SUBJECT: Brunswick Steam Electric Plant, Unit No. 2  
Docket No. 50-324/License No. DPR-62  
Request For License Amendment  
Revision to License Condition - Alternative Source Term

## Evaluation of Proposed License Amendment Request

Subject: Unit 2, Appendix B, "Additional Conditions"  
Alternative Source Term License Condition

Figure 1  
Unit 1 MSIV Seismic Verification Boundary

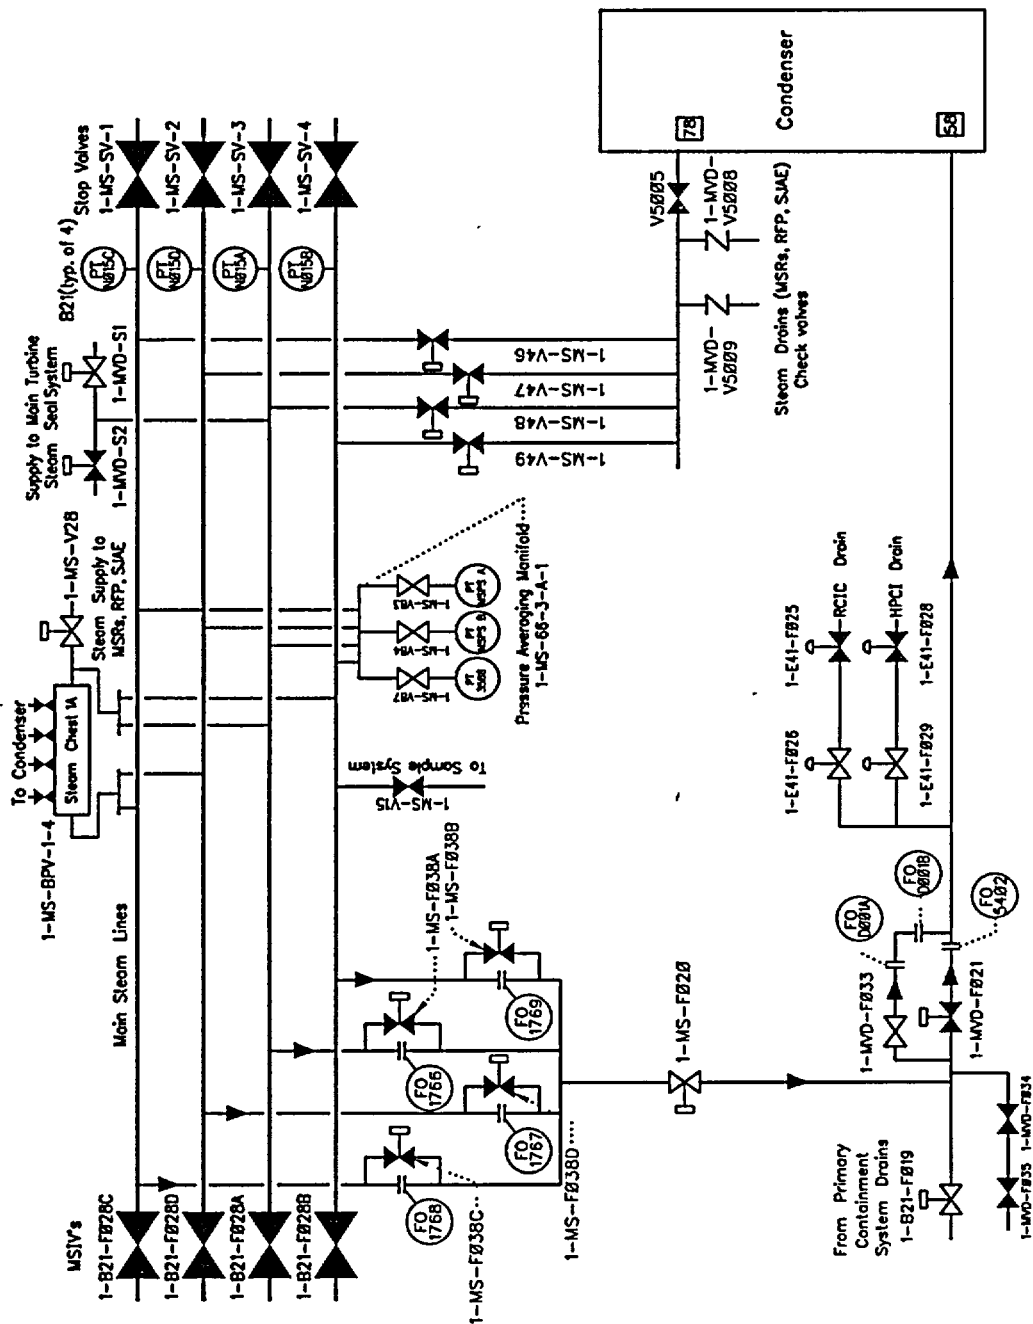
For Unit 1, two check valves (i.e., 1-MVD-V5008 and 1-MVD-V5009) were installed, during the March 2002, Unit 1 Refueling Outage 13, on lines connecting to the main steam drains header which leads to the condenser. Figure 1 provides a diagram of the Unit 1 piping layout. Installation of these valves limited the extent of piping which was within the post-LOCA ALT pathway pressure boundary. Check valves 1-MVD-V5008 and 1-MVD-V5009 have been added to the plant check valve program to ensure their reliability.

Figure 2  
 Unit 2 MSIV Seismic Verification Boundary

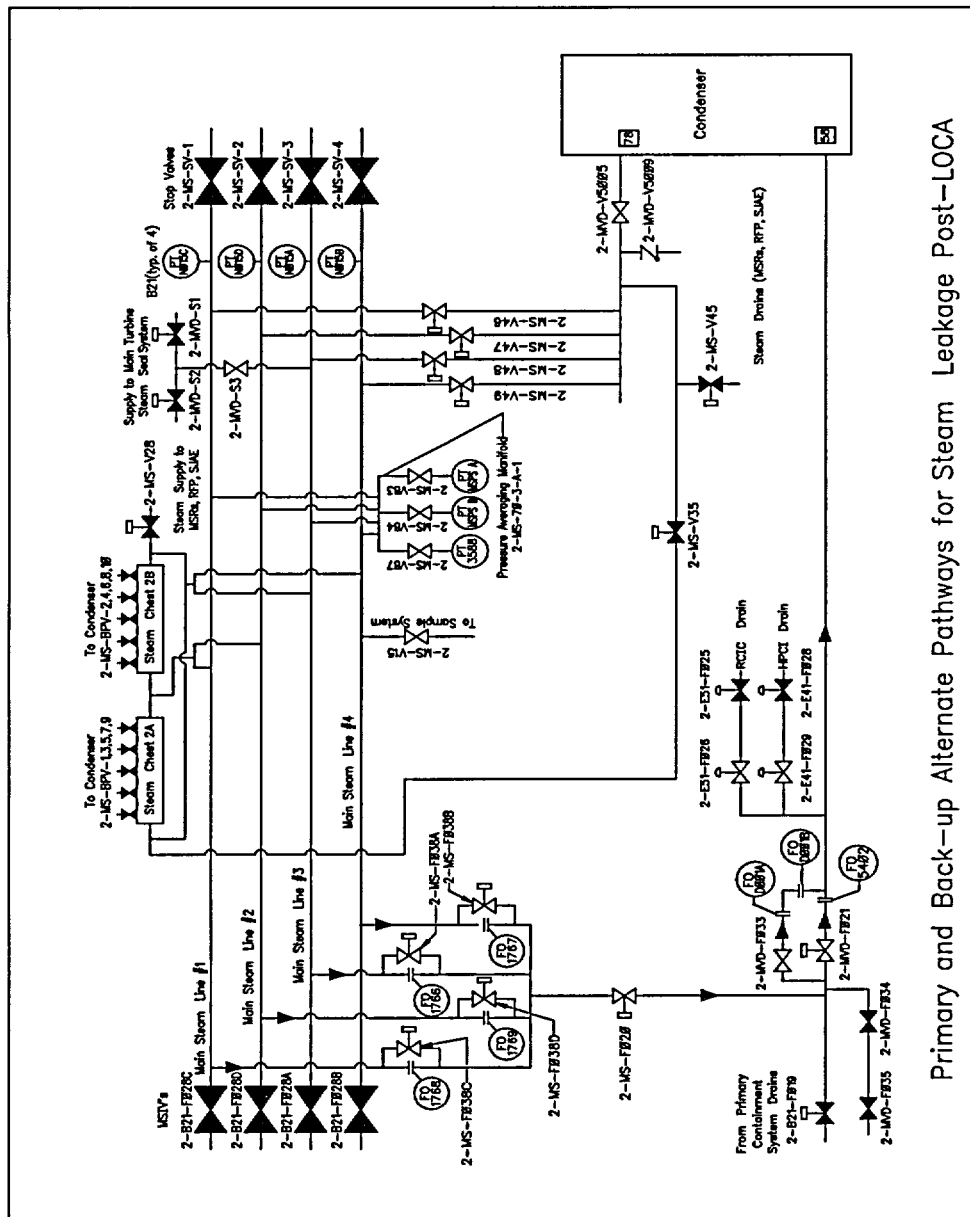
After completion of the Unit 1 modification, a more detailed engineering evaluation of the planned March 2003, Unit 2 Cycle 16 Refueling Outage ALT path modification began. As a result of this work, it has been determined that differences between the Unit 1 and Unit 2 main steam line isolation valve drain piping, which will be within the ALT pathway pressure boundary post-LOCA, obviate the need to install check valve MVD-V5008. This is because the Unit 2 steam bypass system was designed for full bypass capability and thus has two steam bypass chests; whereas Unit 1 has only one steam bypass chest. The Unit 2 design includes a drain line from the steam bypass chest, which ties into the same line that on Unit 1 was isolated post-LOCA by use of the 1-MVD-V5008 valve. Figure 2 provides a diagram of the Unit 2 piping layout. Since the entire line is required to be seismically verified, up to and including the steam bypass chest, there was no benefit in installing the new check valve MVD-V5008 on Unit 2.

As a result of further modification development, it has been determined that only one check valve will be installed (i.e., MVD-V5009) by the Unit 2 alternate leakage treatment piping modification. The proposed license amendment revises the affected license condition, as follows, to require MVD-V5009 be added to the facility check valve program.

<u>Amendment Number</u>	<u>Additional Conditions</u>	<u>Implementation Date</u>
<i>Amendment Number</i>	The licensee shall include ALT path check valve MVD-V5009 in the facility check valve program.	Prior to startup following the Unit 2 Cycle 16 Refueling Outage
